SUBJECT: ISSUANCE OF AMENDMENT NO. 6 TO FACILITY OPERATING LICENSE NO.

R-110 - IDAHO STATE UNIVERSITY AGN-201M RESEARCH REACTOR

2. Safety Evaluation Report

Figure 4.1 Reactor Core

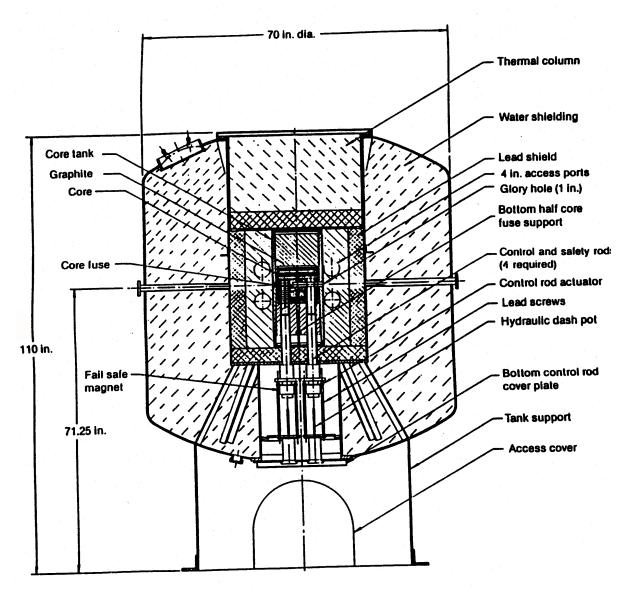
The ISU AGN-201M reactor core (Figure 4.1) is a right cylinder measuring 25.6 cm in diameter, and 24 cm high. The core consists of nine separate fuel-moderator disks containing particles of UO₂ (enriched up to 20% U²³⁵) and particles of polyethylene. The core is contained in a gas-tight aluminum cylindrical tank (32.2 cm in diameter, 76 cm high).

Figure 7.1 Control System

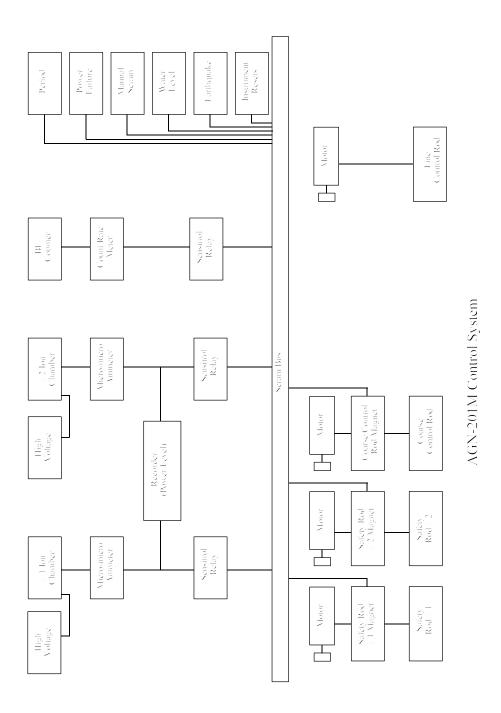
The NRC staff concludes that the I&C systems at the ISU AGN-201M reactor are well designed and maintained.

Figure 11.1 Idaho State University Radiation Protection Organizational Chart

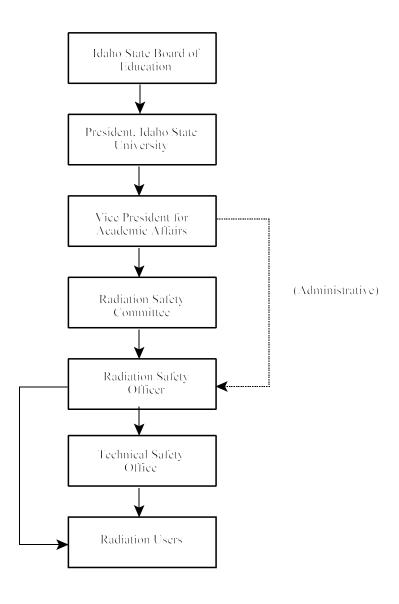
ISU has a structured radiation protection program with a health physics staff equipped with radiation detection equipment to determine, control and document occupational radiation exposures at all university facilities. ISU has assigned the Vice President for Academic Affairs as the Senior Management representative for Radiation Protection at the University. As part of his duties, the Vice President for Academic Affairs has appointed a Radiation Safety Committee (RSC) and a Radiation Safety Officer (RSO). Figure 11.1 is a chart of the ISU management chain with regard to Radiation Protection.
